**Marion County
Board of County Commissioners**

**PLANNING & ZONING SECTION
STAFF REPORT**

P&Z Date: 04/28/2025	BCC Date: 05/20/2025
Case Number	250509ZP	
CDP-AR	32534	
Type of Case	PUD Amendment: Request to 1) add one parcel to PUD; and 2) modify ingress and egress.	
Owner	CORTA Ocala, LLC	
Applicant	N/A	
Street Address/Site Location	8410,8422,8424,8426,8428,8430,8440 SW HWY 200, Ocala FL 34481	
Parcel Number(s)	15 parcels of existing PUD including 3501-200-018, 019, 020, 021, 022, 023, 034, 035, 036, 037, 038, 039 & 040; 3501-400-003 & 004 One (1) added parcel to PUD: 3501-400-002	
Property Size	±9.22 acres	
Future Land Use	Commercial (COM)	
Existing Zoning Classification	Planned Unit Development (PUD) & Community Business (B-2)	
Overlays Zones/Special Areas	Secondary Springs Protection Zone	
Staff Recommendation	Approval with conditions	
P&Z Recommendation	TBD	
Project Planner	Xinyi Cindy Chen	
Related Cases	CORTA PUD: 240506ZP B-2 to PUD – Approved (Concept Plan 05/2024 & Site Plan 08/2024)

Figure 1 – Proposed Amended Corta Commons PUD Site Plan

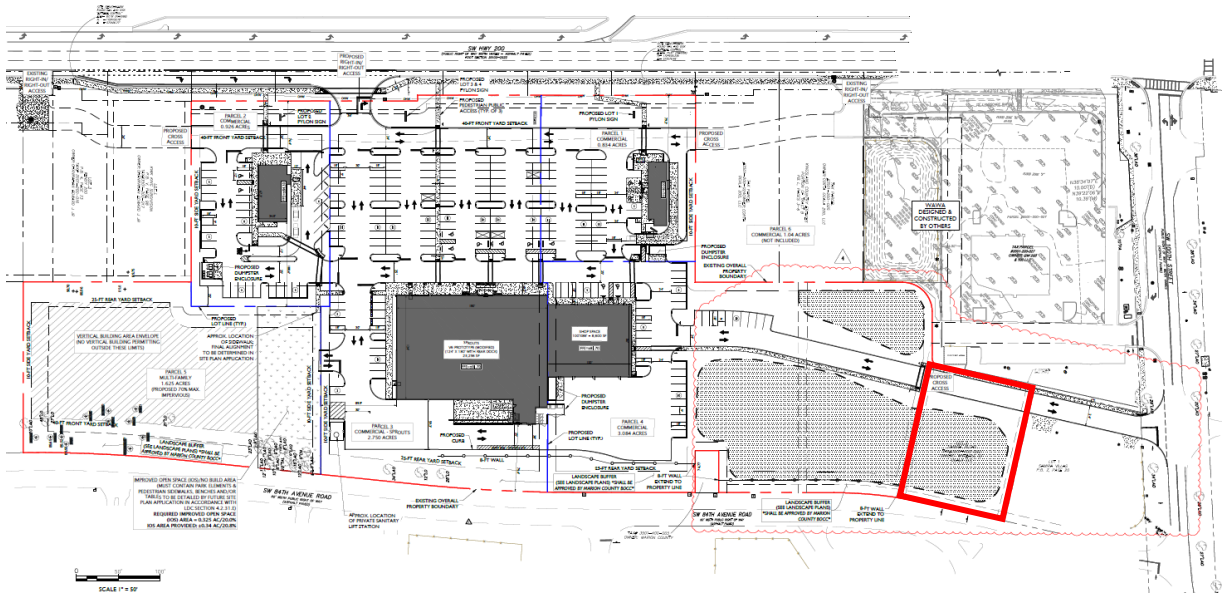
CORTA OCALA, LLC filed a PUD amendment to request two modifications of the approved PUD master plan (see Attachment A). The amendment includes 1) adding one ± 0.48 -acre parcel (3501-400-002) to the Corta Commons PUD; and 2) modifying ingress and egress at SW 100th St by removing approved access through the rear side of Wawa and adding additional cross access and external access through adjacent corner parcel (Samira Villas Lot 1 - PID 3501-400-001). (Figure 1 and Attachment B). The added parcel is currently zoned as Community Business (B-2) and requested rezoning to PUD as part of total ± 9.2 -acre mixed used PUD. The subject property sits in Commercial (COM) land use designation. The site is located within the Urban Growth Boundary and the Silver Springs Secondary Springs Protection Zone. Portions of the site is located in the FEMA Flood Zone A/AE and Zone X.

Figure 3 – Comparison of Approved and Proposed Access**Proposed:****Approved (240506ZP) – cross-access through Wawa.**

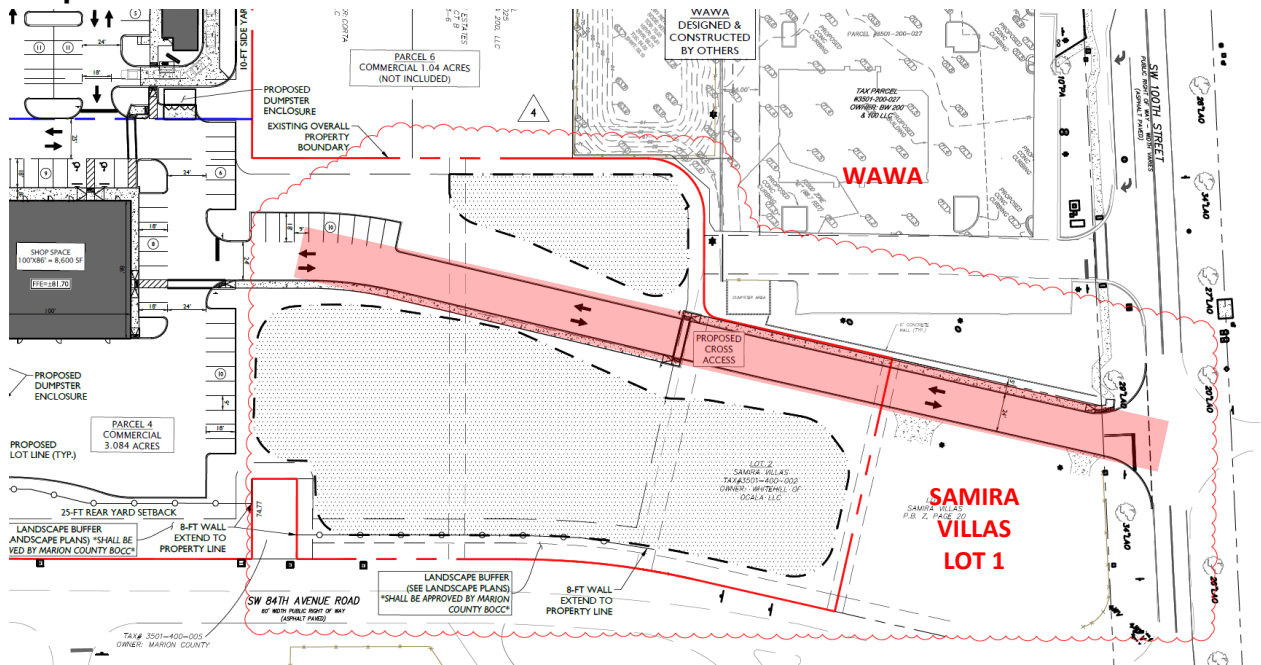
The applicant proposes to modify the approved ingress and egress at SW 100th St by eliminating cross access through Wawa's property to SW 100th St and relocating it through the newly added parcel within PUD and an adjacent property Samira Villas Lot 1 (PID 3501-400-001). The adjacent property, located at the corner of SW 100th St and SW 84th Ave Rd, is zoned B-2 (Community Business) with a Commercial land use designation and is currently used as a residential rental. This modification is requested due to unsuccessful negotiations between the applicant/developer and Wawa regarding cross-access for the Corta Commons development. At the time of this staff report's publication, the applicant has not reached an agreement with the owner of Samira Villas Lot 1 regarding the cross easement for commercial and construction use.

- **Request #2:**
Removal of approved access through the rear side of Wawa is acceptable. The Traffic Study (Attachment F) was conducted using a conservative approach, assuming that cross-access through the rear side of Wawa would not be permitted due to challenges in securing an agreement with Wawa at that time. The Traffic Study was approved based on this assumption that access through Wawa would not be available. Thus, despite the eventual lack of cross-access agreement from Wawa, the remainder of approved access remains adequate to meet the development's needs.

However, Growth Services does not support the proposed additional ingress and egress through Samira Villas Lot 1 due to code noncompliance and its significant impact on the residential property at the corner parcel. First, per LDC Sec. 4.1.4.O, *“Use of residentially zoned property for access. No land which is residentially zoned shall be used for driveway, walkway, or access purposes to any land which is zoned for commercial, industrial, or institutional use.”* While the corner parcel is zoned B-2, its current use is residential. The introduction of commercial traffic is disruptive to residents and the surrounding community. Second, as of the time of this report, the applicant has not provided documentation confirming an agreement with the owner of the corner residential parcel regarding the access easement. Without the adjacent owner's consent, the use of the proposed cross access remains uncertain. According to the LDC, change of approved external access of PUD is subject to the approval of the Board. Its approval could prompt further dialogue with the adjacent owner to facilitate the project moving forward but may also rise challenges from the property's

owner and residents without their consent. In the case that the Board considers approval of the cross access and external access as proposed, staff recommends the Board considering conditions as listed in *Section IV. Staff Recommendation*. Furthermore, the proposed cross access may be used as a construction route. Construction-related activity and traffic through a residential property raise concerns, particularly when lacking an agreement of such uses with the residential property owner and HOA. The applicant is currently coordinating with the Office of the County Engineer (OCE) to obtain comments on this construction route matter.

Therefore, staff does not support the proposed addition of ingress and egress to SW 100th St through residential-use Samira Villas Lot 1 but supports the removal of approved access through the rear side of Wawa. Staff recommends that the ingress/egress to be maintained in accordance with the conditions of the previously approved PUD from case #240506ZP with the removal of the approved access through the rear side of Wawa.

22. Prior to completion and approval of the Site Plan, a cross access easement reflecting the revised use and configuration of the cross-access through Parcel 3501-400-001 shall be submitted and approved to the satisfaction of the County Engineer and Growth Services director, in a form acceptable to the County Office of Engineer. The easement shall be signed by all affected property owners.

22. Alternative for #22 above:

Prior to completion and approval of the Site Plan, provide the County Engineer and Growth Services director a copy of the easement to ensure that all affected property owners are in agreement with the access through Parcel 3501-400-001.

24. The cross-access driveway connecting the approved PUD development site to SW 100th St shall be designed and constructed in accordance with County standards and as approved by the County Engineer.

Figure 3 – Proposed Added Parcel

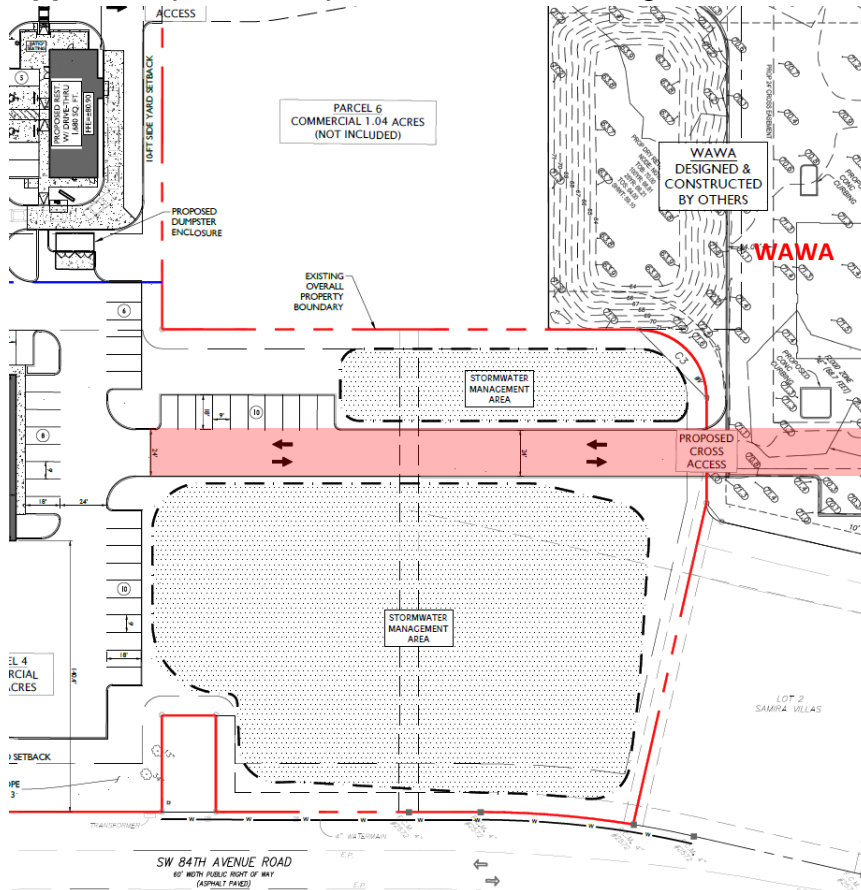
The applicant proposes to add one 0.48-acre parcel 3501-400-002 to the PUD development (see red box in Figure 3). The added parcel has been purchased and owned by the applicant/developer CORTA Ocala LLC. The added parcel is located on the east side of existing PUD and adjacent to the existing PUD. The use of this additional parcel is proposed to be used as an extension to approved DRA and an easement for proposed driveway relocation from PUD commercial area to SW 100th St.

- The added parcel requires rezoning from B-2 to PUD aligns with the approved development.
- The proposed modification meets density and FAR of the PUD within the limits stipulated by the county zoning ordinance and previous approved PUD resolutions.

- The expansion of PUD by including one additional parcel and its proposed uses as DRA with a driveway did not alter the overall intention of approved PUD.

- E. **Buffers between the added parcel #3501-400-002 and adjacent residential use parcel 3501-400-001 shall be provided per LDC requirement,**
 - ~~E. F.~~ Buffer types and illustrations shall be submitted with the site plan phase for approval.
